**ADDENDUM NO. 2**

**DATE:** August 22, 2025

**PROJECT:** UNCCH Phillips Hall 1958 HVAC Renovation  
SCO ID # 22-25029-02A  
UNC CIP # 21400

**1 FIRST FLOOR PLUMBING DEMOLITION PLAN**  
Scale: 1/8" = 1'-0"

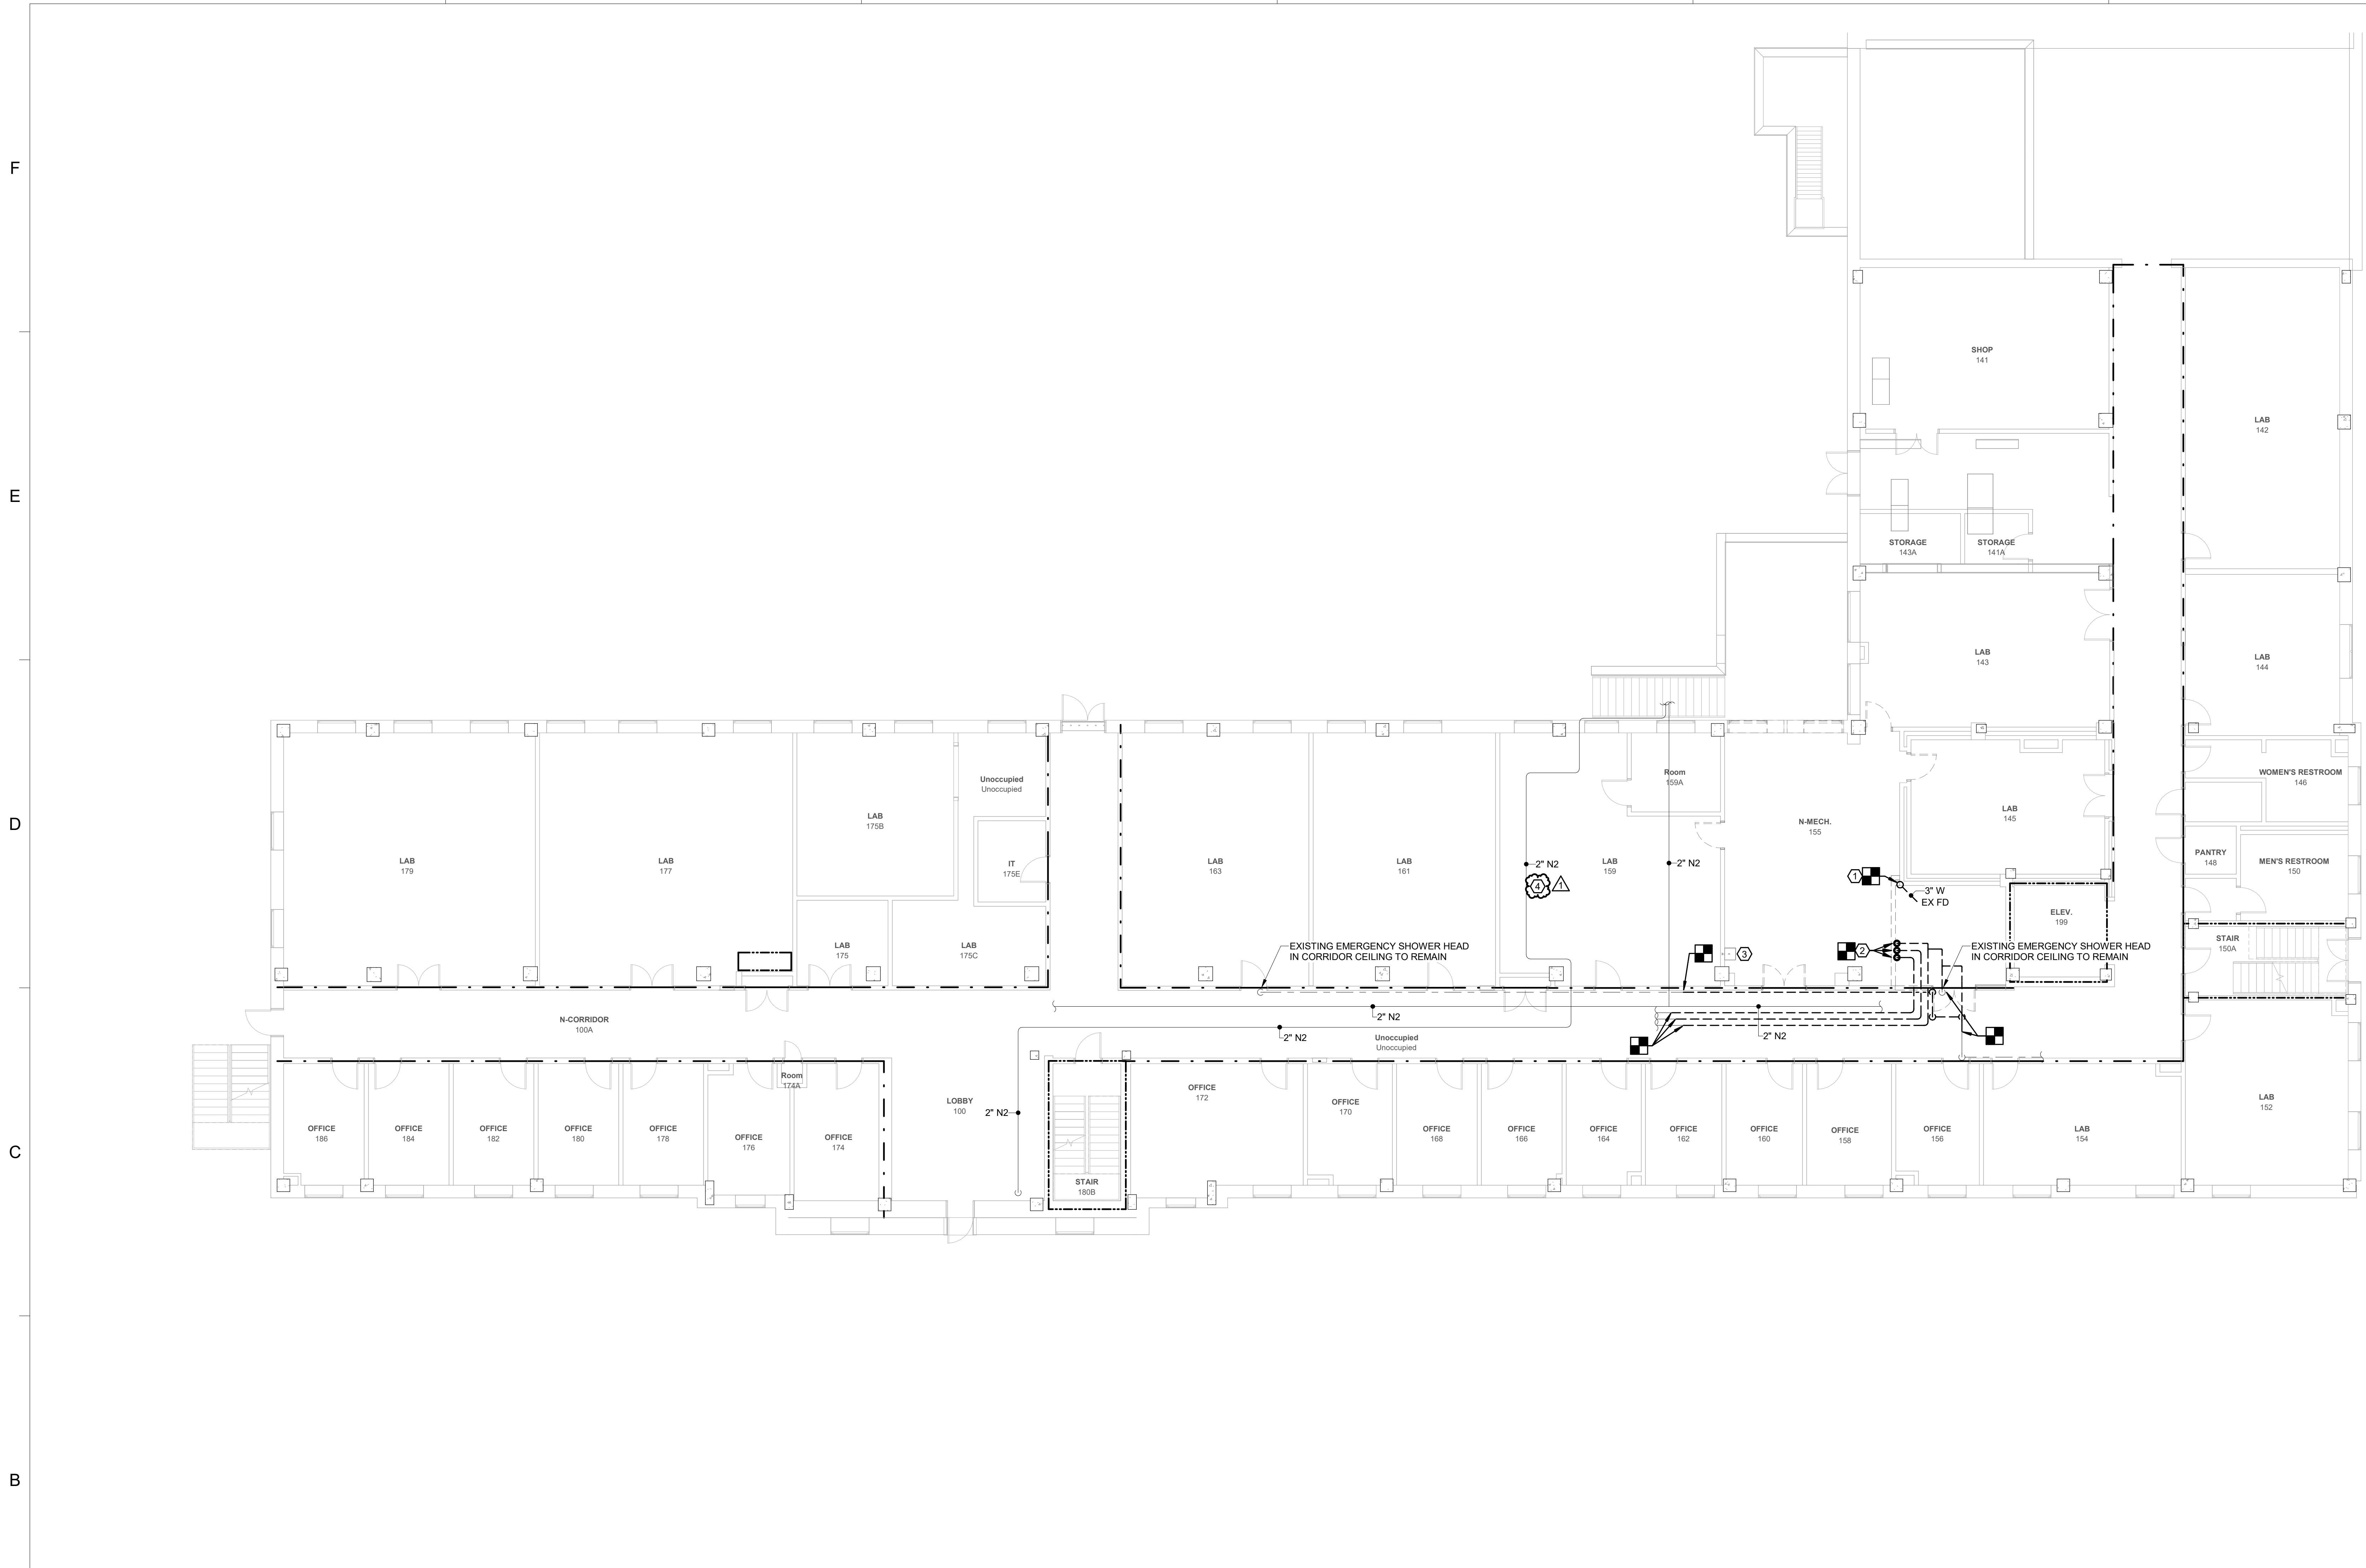
- 1. DEMOLISH STORM STACK FROM THE FIRST FLOOR UP TO THE ATTIC.
- 2. DEMOLISH EXISTING DOMESTIC WATER RISERS UP FROM GROUND FLOOR.
- 3. DEMOLISH EXISTING SINK AND PIPE CONNECTIONS BACK TO MAIN AND CAP.
- 4. PLUMBING CONTRACTOR TO PROVIDE PRICING TO REWORK SEVENTY-FIVE (75) LINEAR FEET OF NITROGEN PIPING INSIDE LAB 159 TO AVOID DUCTWORK SHOULD DEMOLITION REVEAL INADEQUATE HEIGHT TO PREVENT CONFLICTS BETWEEN THE EXISTING NITROGEN PIPING AND THE NEW DUCTWORK INSTALLATION. REFER TO MECHANICAL PLANS FOR ADDITIONAL DETAILS REGARDING THE NEW DUCTWORK. PRICING TO BE BASED UPON HARD-DRAWN COPPER PIPING WITH CAST COPPER FITTINGS AND BRAZED JOINTS. COST SHALL INCLUDE ALL HANGERS AND SUPPORTS REQUIRED FOR PIPING REWORK.

**1 FIRST FLOOR DOMESTIC WATER PLAN**  
 Scale: 1/8" = 1'-0"

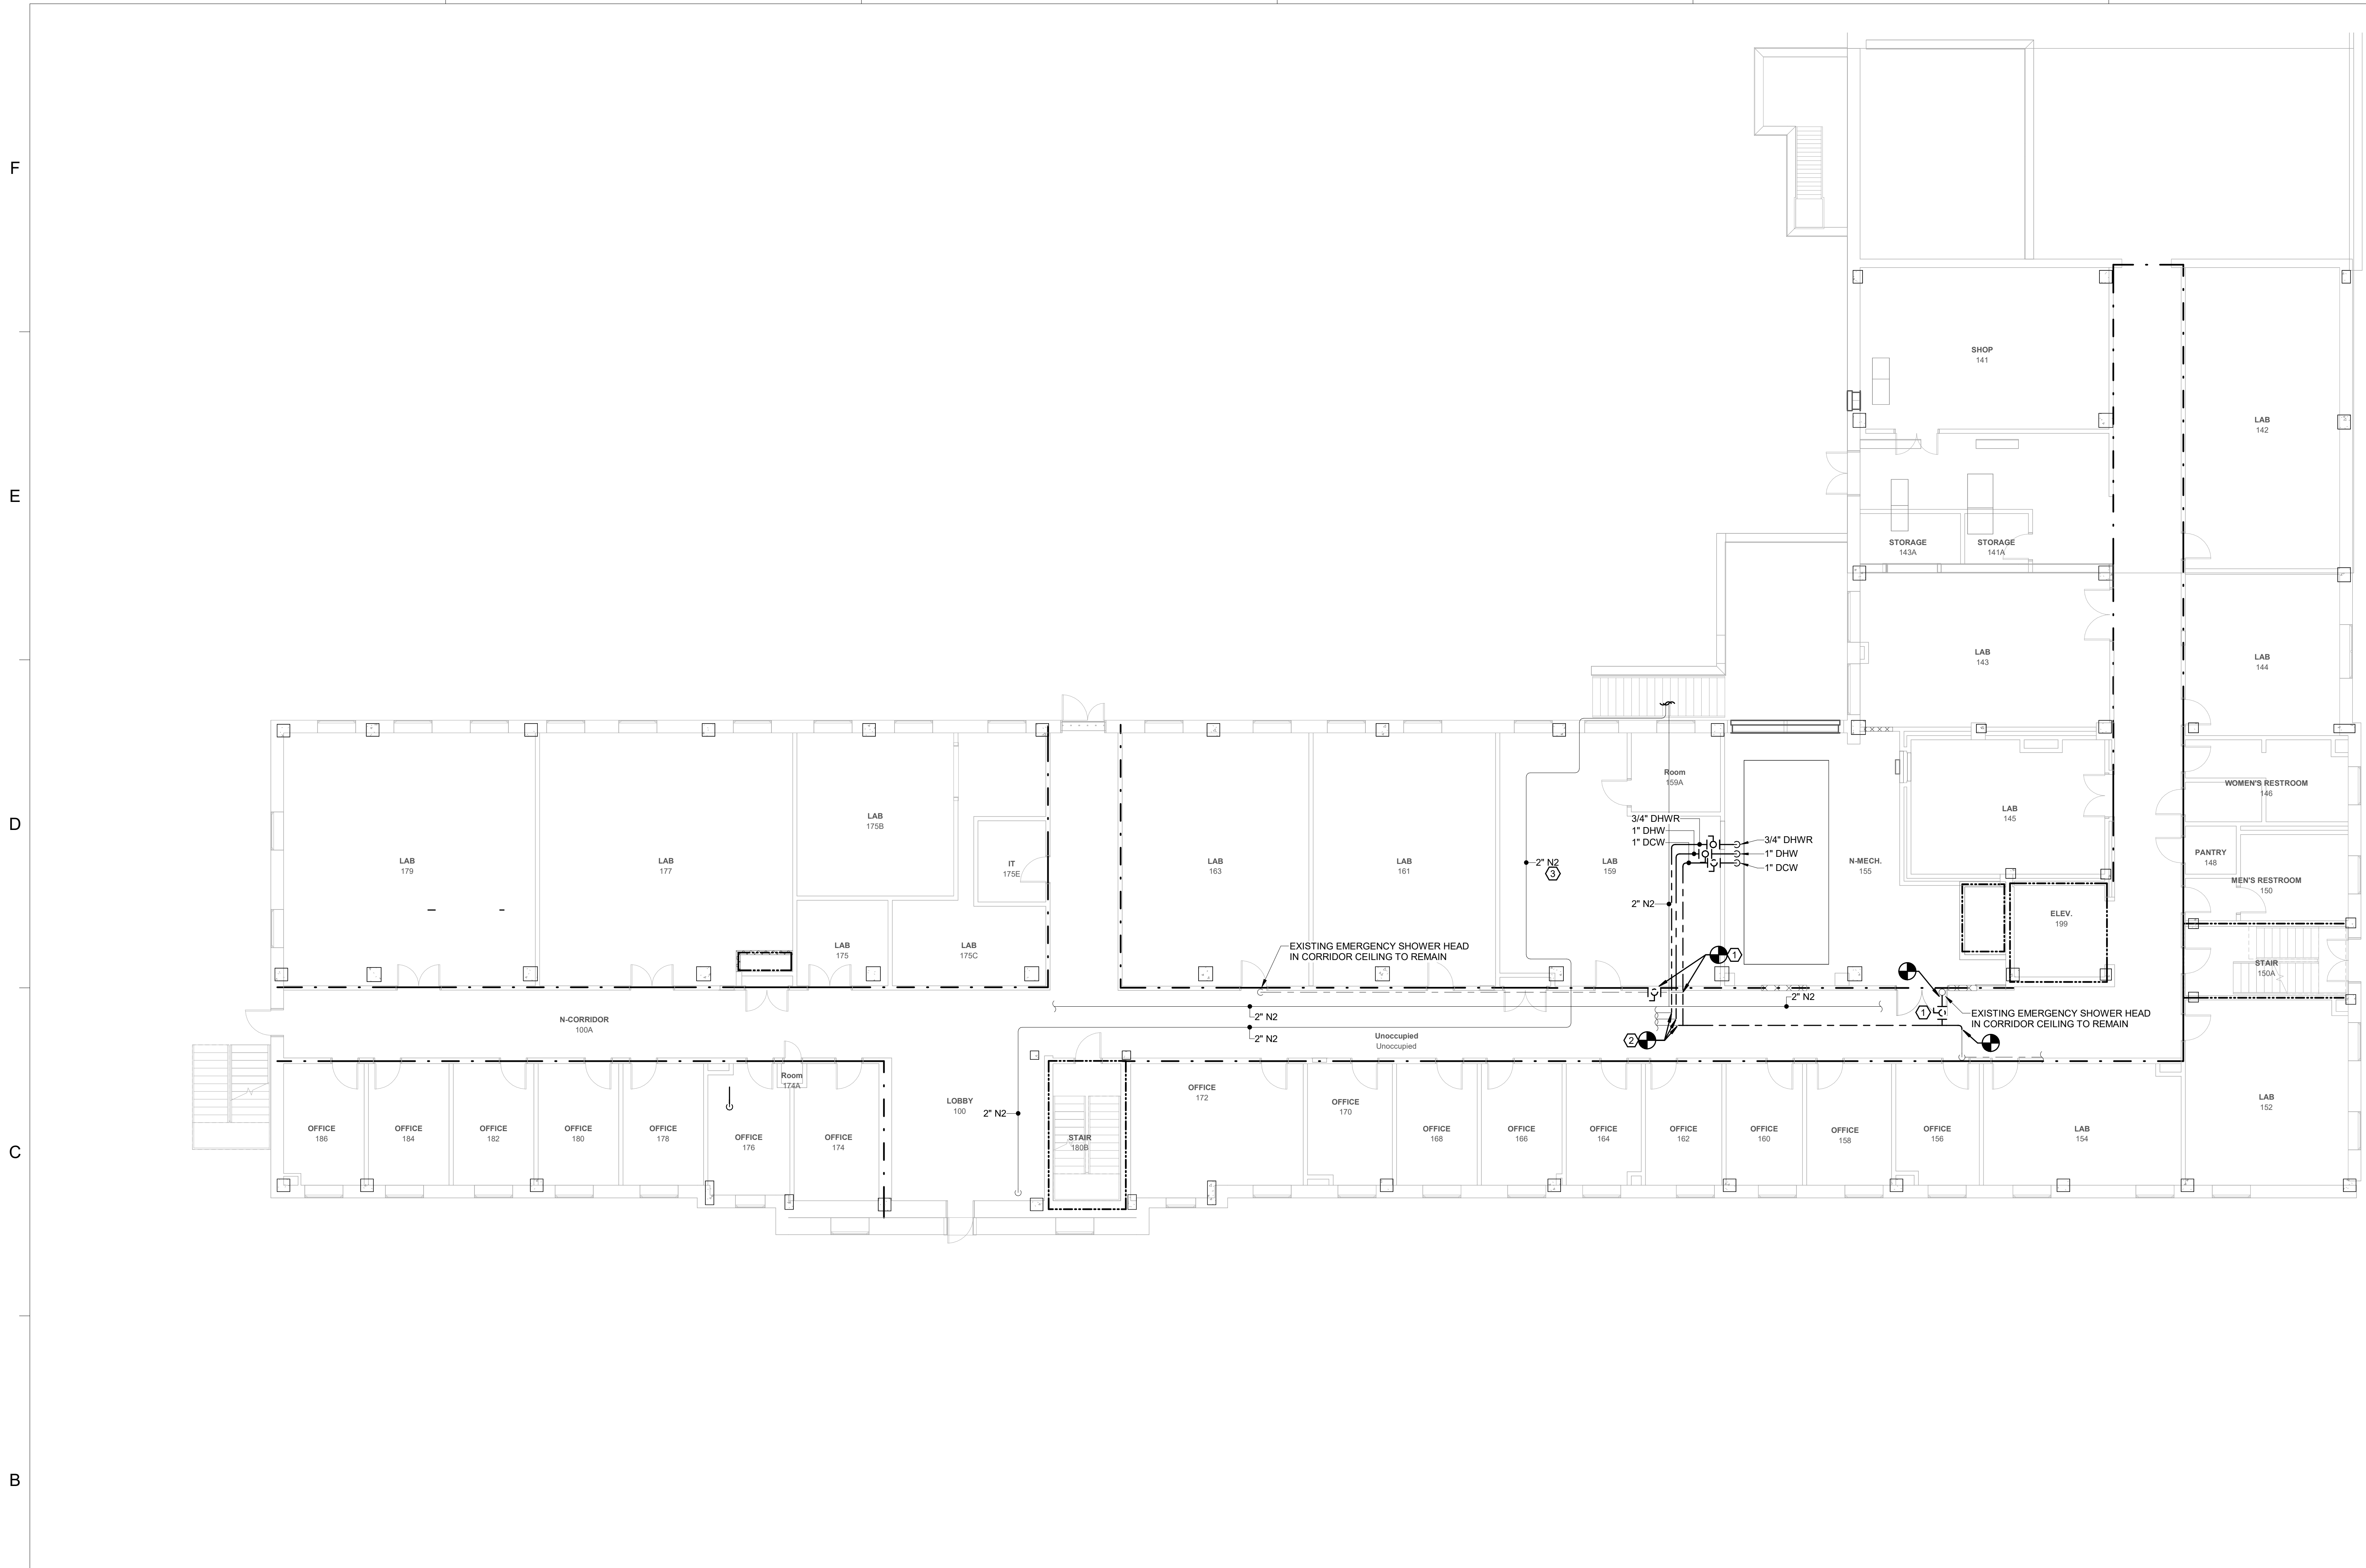
- PROVIDE ISOLATION VALVE FOR EMERGENCY FIXTURE LOCKED OPEN. COORDINATE LOCKS WITH UNC FACILITIES.
- CONNECT NEW DOMESTIC WATER SERVICE TO EXISTING DOMESTIC WATER MAINS. PROVIDE ISOLATION VALVES IN DROPS.
- PLUMBING CONTRACTOR TO PROVIDE PRICING TO REWORK SEVENTY-FIVE (75) LINEAR FEET OF NITROGEN PIPING INSIDE LAB 159 TO AVOID DUCTWORK SHOULD DEMOLITION REVEAL INADEQUATE HEIGHT TO PREVENT CONFLICTS BETWEEN THE EXISTING NITROGEN PIPING AND THE NEW DUCTWORK INSTALLATION. REFER TO MECHANICAL PLANS FOR ADDITIONAL DETAILS REGARDING THE NEW DUCTWORK. PRICING TO BE BASED UPON HARD-DRAWN COPPER PIPING WITH CAST COPPER FITTINGS AND BRAZED JOINTS. COST SHALL INCLUDE ALL HANGERS AND SUPPORTS REQUIRED FOR PIPING REWORK.
